Woollahra Local Planning Panel (Electronic Meeting)

Thursday 19 September 2024 at the Conclusion of the Public Meeting

LOCAL PLANNING PANEL DEVELOPMENT APPLICATION ASSESSMENT REPORT

The subject site is located at 12 Kulgoa Road, Bellevue Hill and is legally described as Lot B DP 365759. The site is on the southern side of Kulgoa Road between Kulgoa Lane to the west and Yamba Road to the east and is irregularly shaped with a northern street frontage of 24.384m to Kulgoa Road and a total site area of 435.7m².

Proposed Lower Floor Plan (Source: Cave Urban)

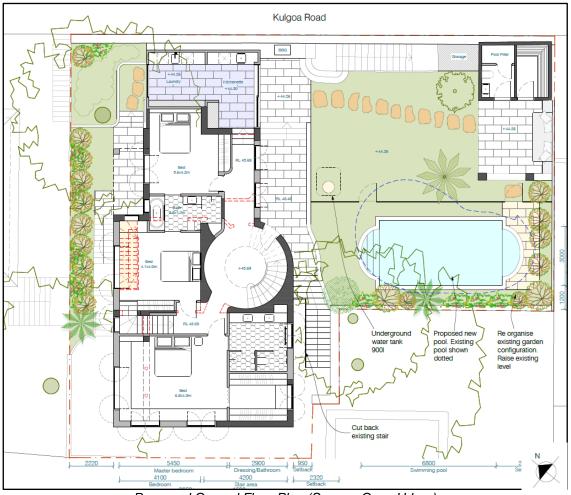
- "Reconfiguring the storage area and internal stairs on the Lower Ground Floor;
- Extending the external stairs on the north-western side of the Lower Ground Floor;
- Constructing new external stairs leading from the pedestrian gate at the south-eastern end of the site to the private open space area."

First Floor - (RL 46.76)

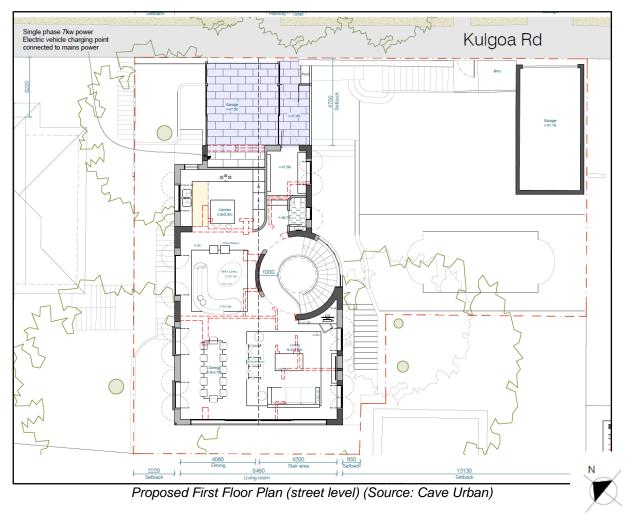
- "Extending the front part of the First Floor to the northwest and reconfiguring the floor layout of the First Floor;
- Removing the front part of the First Floor and constructing a new single garage at the northwestern end of the site and a new dwelling entry at the First Floor".
